SUBJECT: Monmouth Municipal Airport
Monmouth, Illinois
Warren County
Illinois Project Number: C66-4186
SBG Project Number: 3-17-SBGP-120/133
Contract No. MO005
Item No. 05A, April 28, 2017 Letting
Addendum A

NOTICE TO PROSPECTIVE BIDDERS

Adjustment made to fence alignment/tie-in at Southeast corner of property.

CONSTRUCTION PLANS - FEBRUARY 24, 2017 INSTALL PERIMETER SECURITY FENCE

PROPOSED FENCE PLAN-EAST

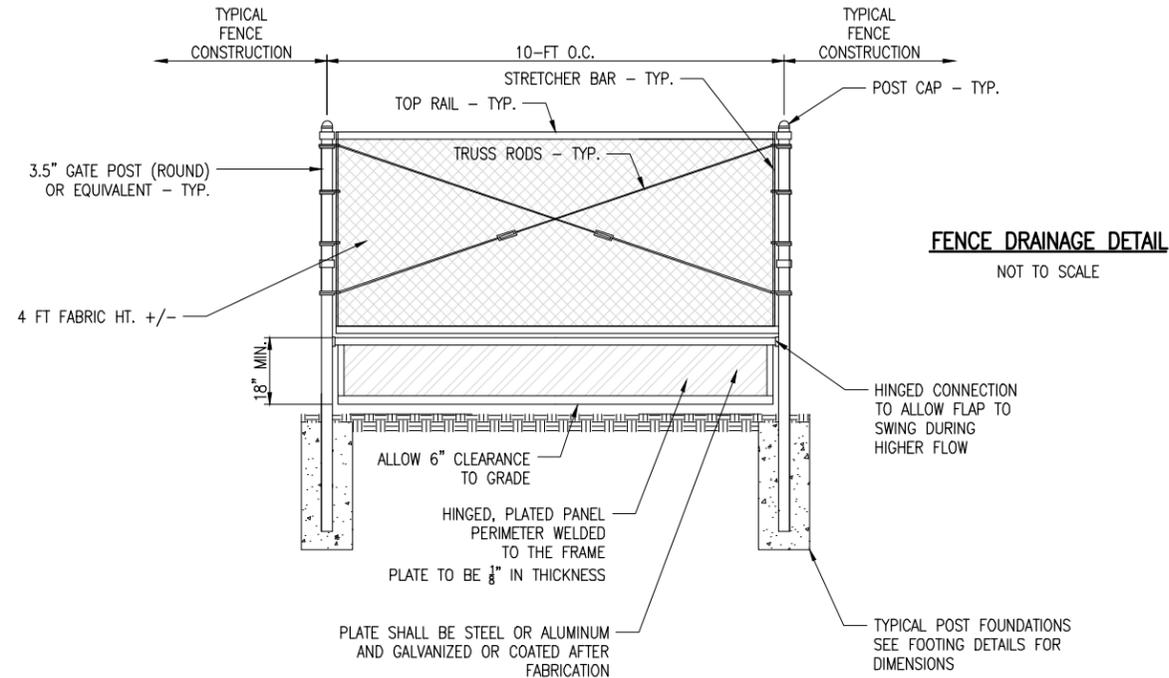
Plan Sheet 7 of 10. **Proposed Fence Plan-East**

- Revised fencing at Southeast corner of property to chamfer behind existing sign instead of tying into.

FENCE TO PEDESTAL DETAIL
NOT TO SCALE

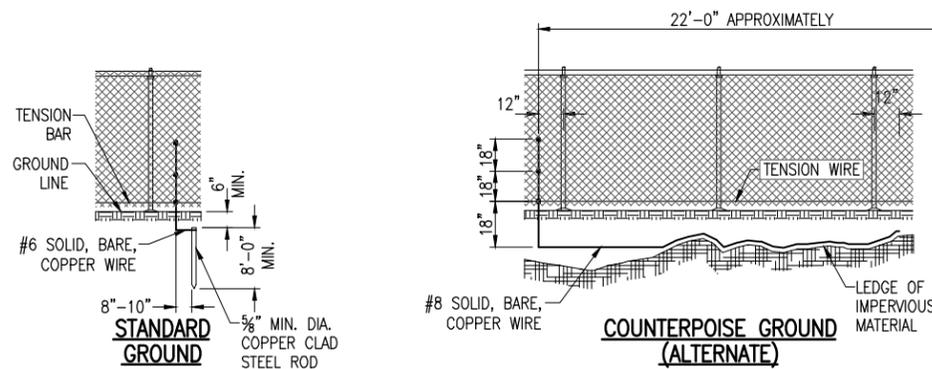
Plan Sheet 9 of 10. **Fence Details and Notes**

- Marked out Fence to Pedestal Detail
